*Remarks to the proposal for draft 01 series of amendments to regulation 66(document  
TRANS/WP.29/GRSG/2003/25)*

*(Transmitted by the expert from Spain)*

Figure A5.1 - Geometry of the tilting bench

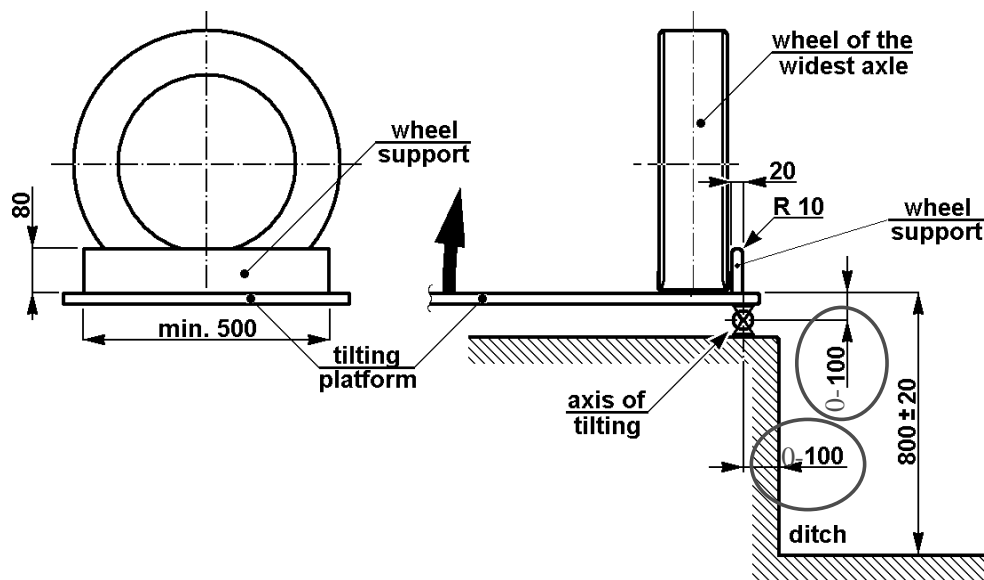
Figure A5.1 modified in agreement with paragraph 1.3 of this annex:

Justification: As it is defined in paragraph 1.3 of this annex, the distance from the axis of rotation to the vertical wall of the ditch is 100 mm maximum (that is 0-100 mm) and the axis of rotation is max 100 mm below the plane of the horizontal tilting platform (that is 0-100 mm). However, in figure A5.1 both distances are fixed as 100 mm.
